Art. 12, Div. 5,
Hobe Sound Community Redevelopment Code
and
Amendment of Zoning Atlas

Public Comment

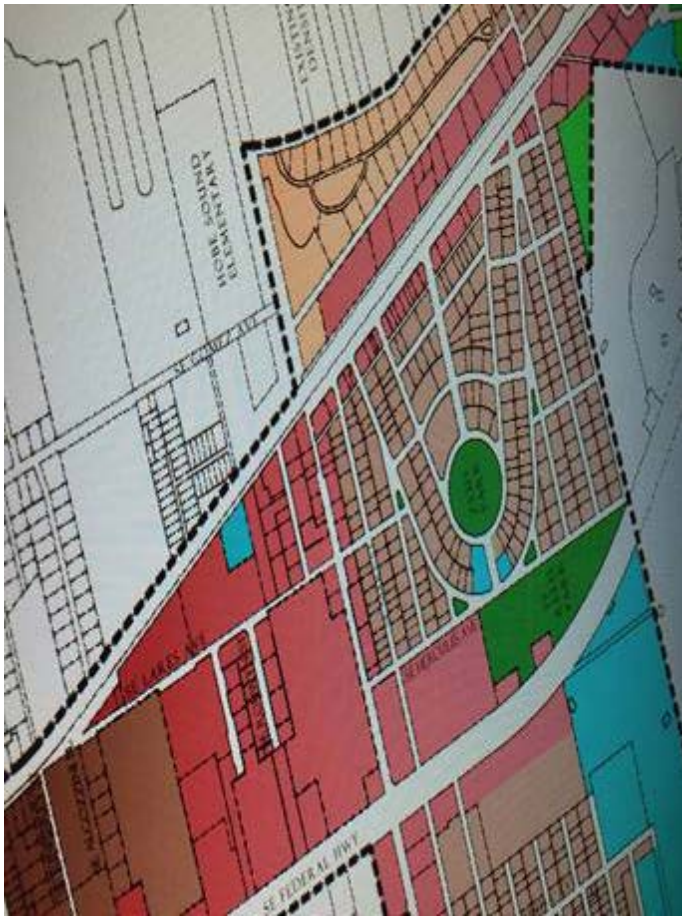
On the attached slide from your presentation, the CRA Center subdistrict includes Core and General, while the CRA Neighborhood includes Multifamily Homes and Detached Homes. I noticed on the FLUM that Zeus Park has been designated CRA Neighborhood. This does not make sense to me because there are areas within Zeus Park that will be in the General subdistrict. This is inconsistent with your slide. Can you explain the disconnect or am I simply misreading it?

Why is urban farming limited to the Railroad Corridor subdistrict?

Lastly, I noticed some parcels have been changed from General to Multi-family in Zeus Park. What was the rationale for this? Did the parcel owners request the change?

The CRA General Subdistrict (zoning) is permitted within the CRA Center and CRA Neighborhood FLU. We are trying to balance what currently is allowed within the existing zoning and FLU districts and overlays, in doing so we have some cases where the

General Subdistrict is applied in both the Center & Neighborhood FLU.

Urban farming is a new use group that we have recommended. Its includes two new uses of Agri-hood and Urban Agriculture. These uses and Farmer's Market are not currently permitted within Hobe Sound CRA (there was some community discussion about allowing this use within the CRA). We felt that the new Railroad Corridor Subdistrict would be the most appropriate place to allow this use (versus in the neighborhoods or Center).

The General subdistrict would have expanded the permitted uses from what is currently permitted today. Many of those parcels currently have an RM-5 zoning category which allows multi-family. Again, this was a decision based upon what is currently allowed and not impeding upon anyone's rights.
